ADDENDUM NO. 2

Rock 'N River Family Aquatic Center Expansion, Round Rock, Texas

From: City of Round Rock and Kimley-Horn and Associates, Inc.

Figure 307.2 Limits of Protruding Objects

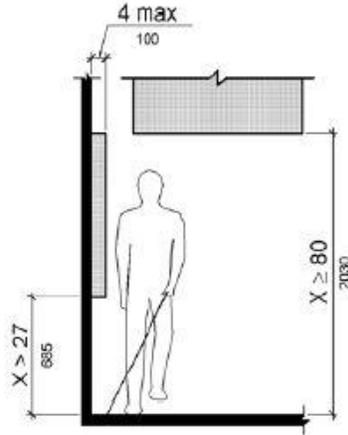
****Note: The baby changing table shown on Sheet A1-100 may be considered a protruding object when left in the down position. Therefore, the unit should be mounted with the bottom of the changing table no higher than 27 in. above the finished floor. Compliance with the technical requirements referenced in Section 307.2 shall be verified during inspection. See also additional information in Fig. 307.2.**

SITE PLAN - ELECTRICAL DISTRIBUTION
 SCALE: 1" = 30'-0"

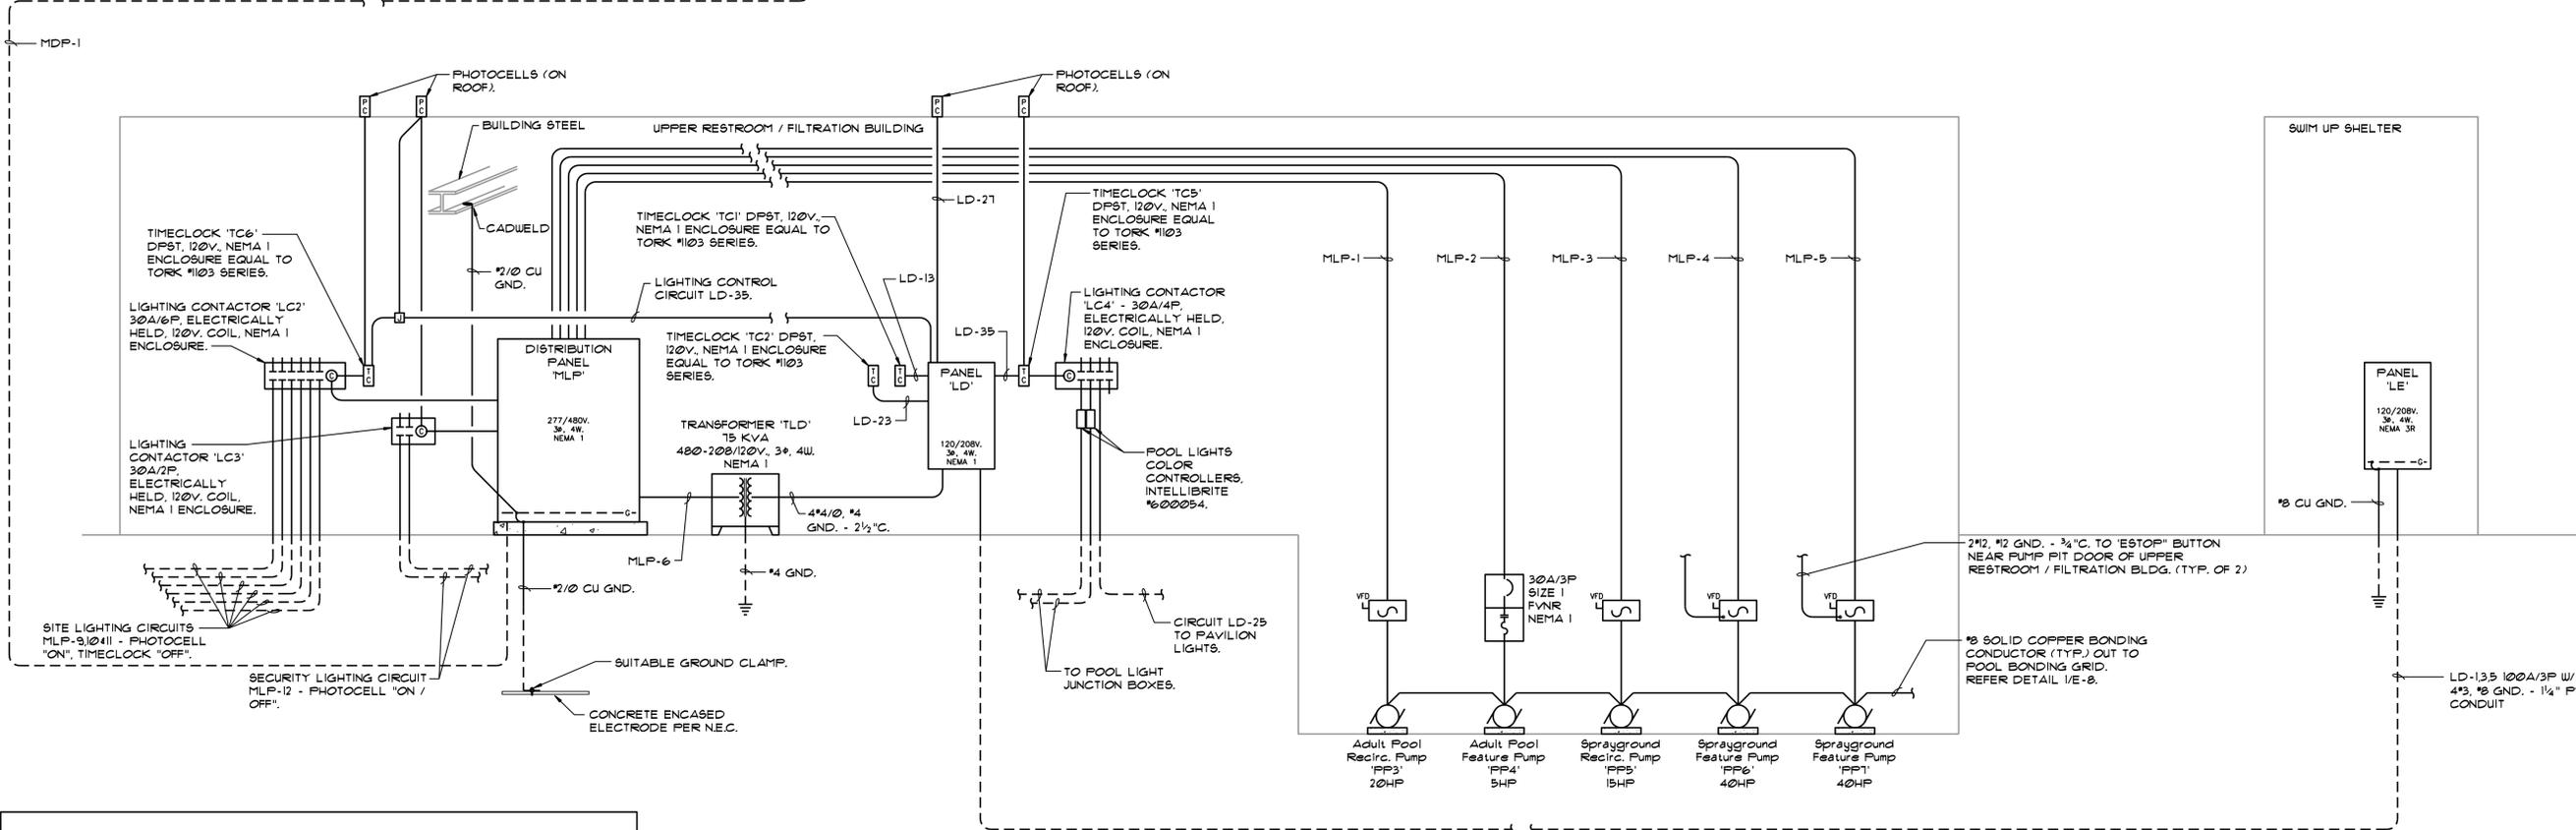
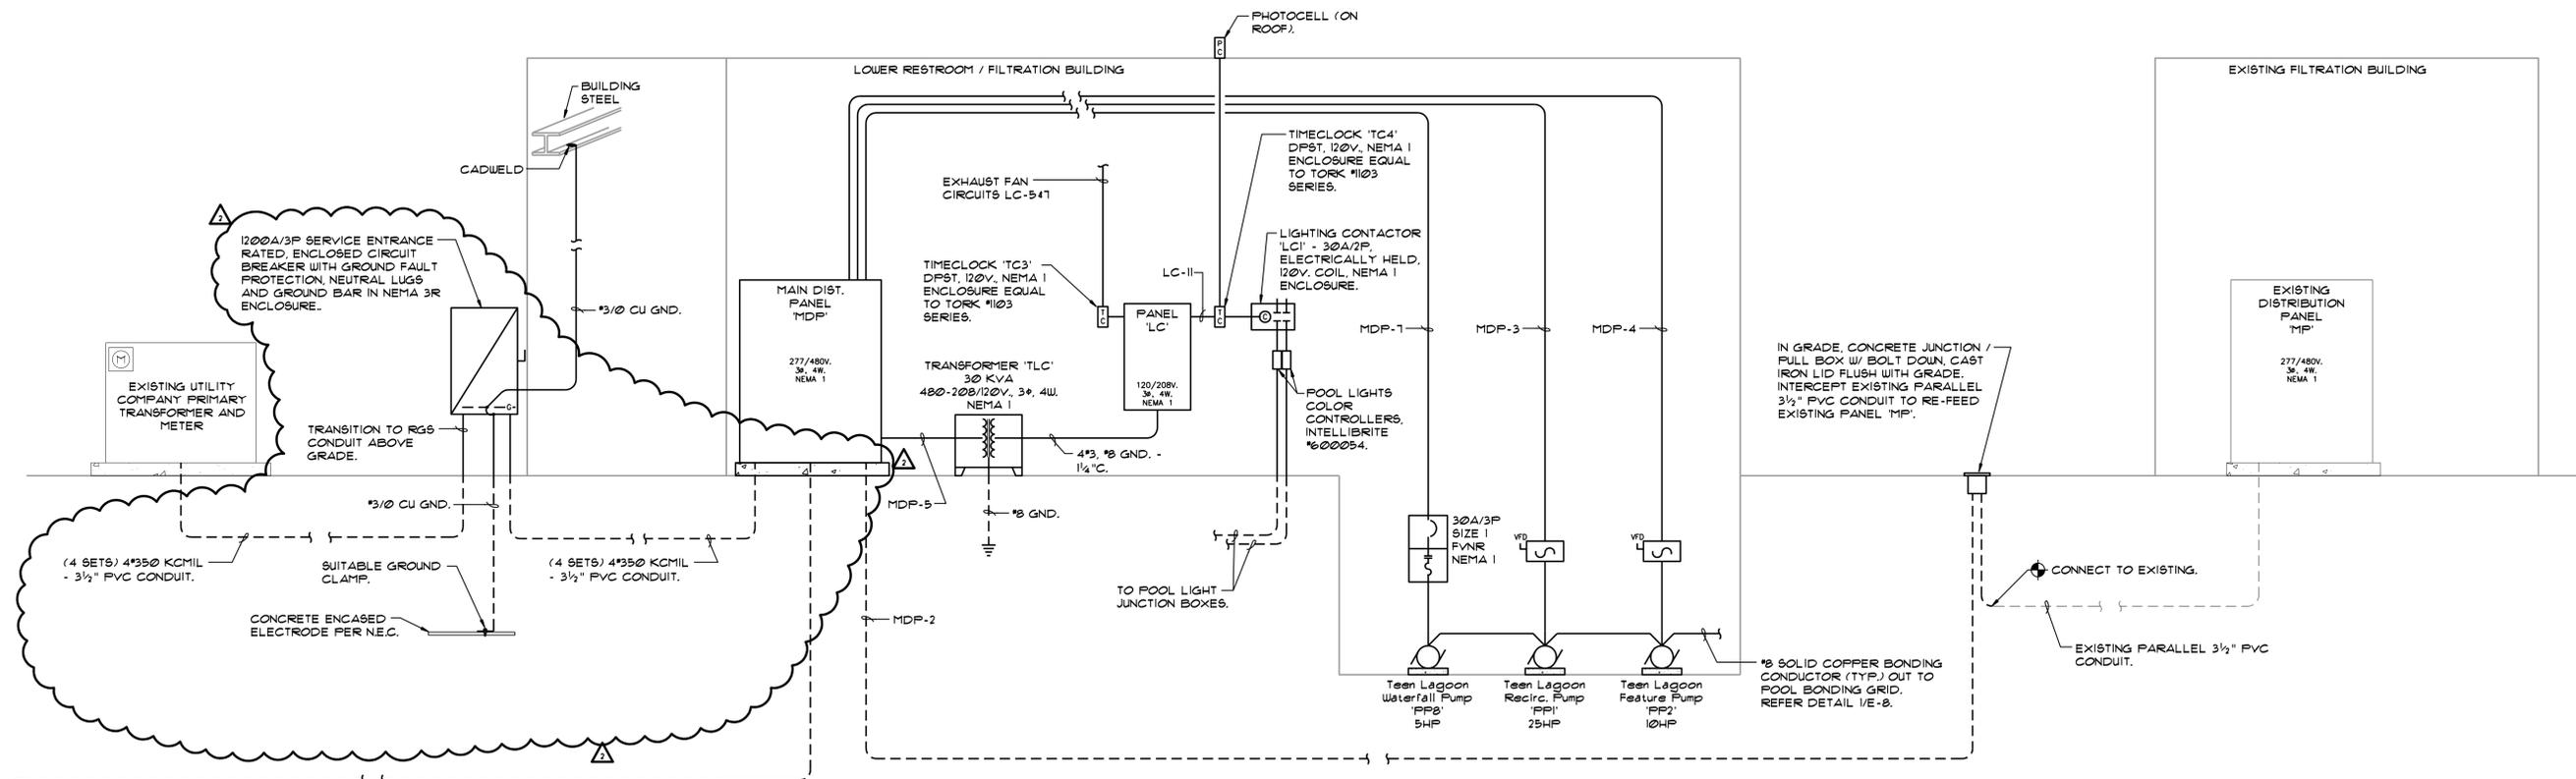
1. **SHEET E-1 "SITE PLAN – ELECTRICAL DISTRIBUTION"**
 - a. Added 1200A/3P service entrance rated, enclosed circuit breaker with ground fault protection for new incoming electrical service per Oncor's requirements
2. **SHEET E-6 "ELECTRICAL RISER DIAGRAM"**
 - a. Added 1200A/3P service entrance rated, enclosed circuit breaker with ground fault protection for new incoming electrical service per Oncor's requirements
3. **SHEET E-7 "ELECTRICAL PANEL SCHEDULES"**
 - a. Main Distribution Panel "MDP" schedule, changed from main circuit breaker (M.C.B) to main lugs only (M.L.O)
